Planning Officer's Report - LDCA NOVEMBER 2023

APPLICATION	2023/51 – Change of Use from One Dwelling to Two Dwelling Units & Retention of Septic Tank & Soakaway
PERMISSION SOUGHT	Full Permission
REGISTERED	28 th September 2023
APPLICANT	Theo Meij
PARCEL	SCOT0670
LOCALITY	Upper Cleughs Plain, St Pauls
ZONE	Intermediate Zone
CONSERVATION AREA	None
CURRENT USE	House in Construction
PUBLICITY	The application was advertised as follows: <ul style="list-style-type: none">▪ Independent Newspaper on 29th September 2023▪ A site notice displayed in accordance with Regulations.
EXPIRY	13 th October 2023
REPRESENTATIONS	One Received
DECISION ROUTE	Delegated / LDCA / EXCO

Diagram 3: Proposed Septic Tank & Soakaway

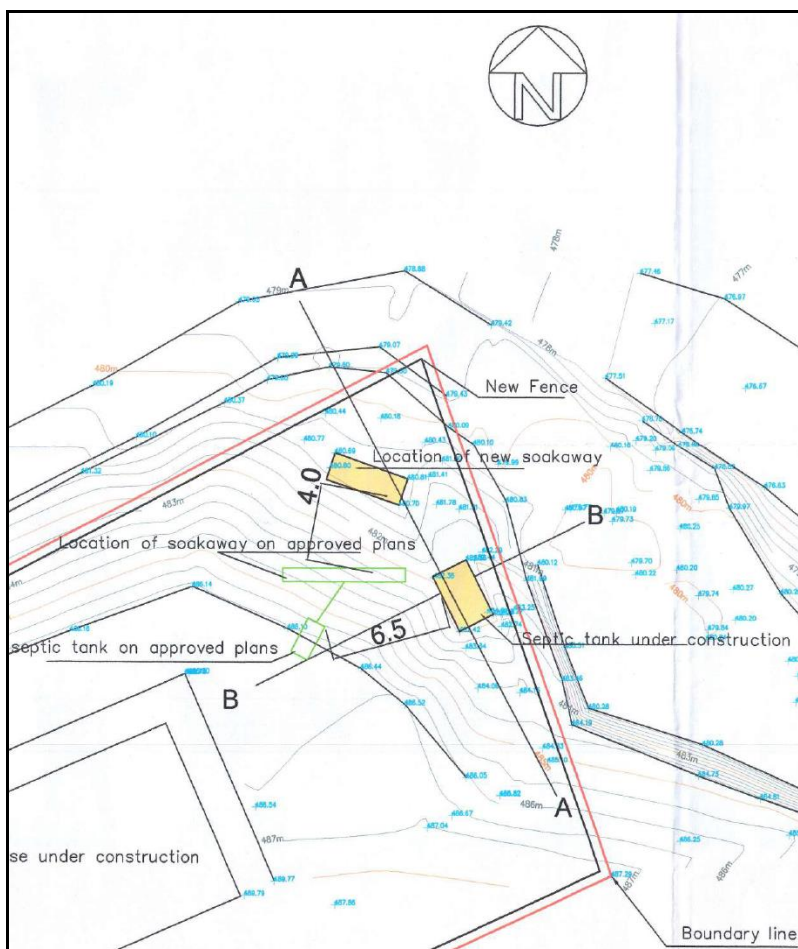
Neighbours Representation - Concerned about the close proximity of the sewage tank, which is located adjacent to the front of my house and next to the proposed outside cooking space and the risks associated with density of the ground and the leakage from the soakaway onto my property. The associated odour with a sewage tank will not be masked by the proposed solution.

The initial scheme was presented prior to the application being submitted, where the Building Inspectors provided the following advice – “In reviewing the plans submitted on Theo’s behalf by Melvyn we don’t feel this satisfies the regulation of being underground, we would however compromise to say that 300mm maximum exposed would be satisfactory providing it meets all other requirements of the regulation.’

Building Regulation H.3 (2) states that “Any septic tank shall be under ground on its completion”

A well-functioning septic tank should not give of odour unless there is an issue with the system. The regulation requires the septic tank to be vented at least 7m from any habitable part of a building, this means a septic tank could potentially be built next to a building provided the vent is located a minimum 7m away from any habitable room.

Comments from the civil engineer concerning the soakaway -‘After reviewing the proposal, I feel if the percolation test results are a true reflection of the ground conditions I see the revise location of the soakaway not being a major issue. In fact the trench invert level is lower the road level therefore in theory water would percolation in a downwards direction. It also could be argued that original soakaway location pose a risk of horizontal seepage due to its higher invert level in comparison to the road, i.e. the water can be seen to percolation through the embankment, a

common occurrence if water does not percolate quick enough. I am not advising this is how the system will ultimately perform therefore I suggest some reasonable planning safeguards are conditioned in the event the system do not perform as intended.'

Following this advice from the Building Inspectors, the agent was advised accordingly and has agreed to comply with this requirement with compacting the fill on the eastern side of the tank to a height, where only a maximum of 300mm is exposed above ground. Concern has been raised regarding the material to be backfilled as Section BB does not show any form of retainment. Assurance has been given by the agent that this will not be an issue. A methodology has been requested, and at the time of writing the report has not been received, however will be brought to the attention of members at the meeting once received. Visually the septic tank will be hidden behind the fence from the eastern side.

At the time permission was granted for this development, there was no proposal for an access road beneath this property. As mentioned by the engineer the original location might have posed a risk in terms of horizontal seepage due to its higher invert level in comparison to the road, however due to more land mass between the soakaway and the road, this might help with overall dispersing of effluent. The new location of the soakaway has been constructed closer to the access road, however at a depth beneath the road level. Based upon this information and the test results provided by the developer, the likelihood of seepage onto the access road in theory is considered low and therefore can be supported on this basis. As highlighted by Property Division, in the event a problem occurs, it is the responsibility of the developer to rectify or relocate the soakaway.
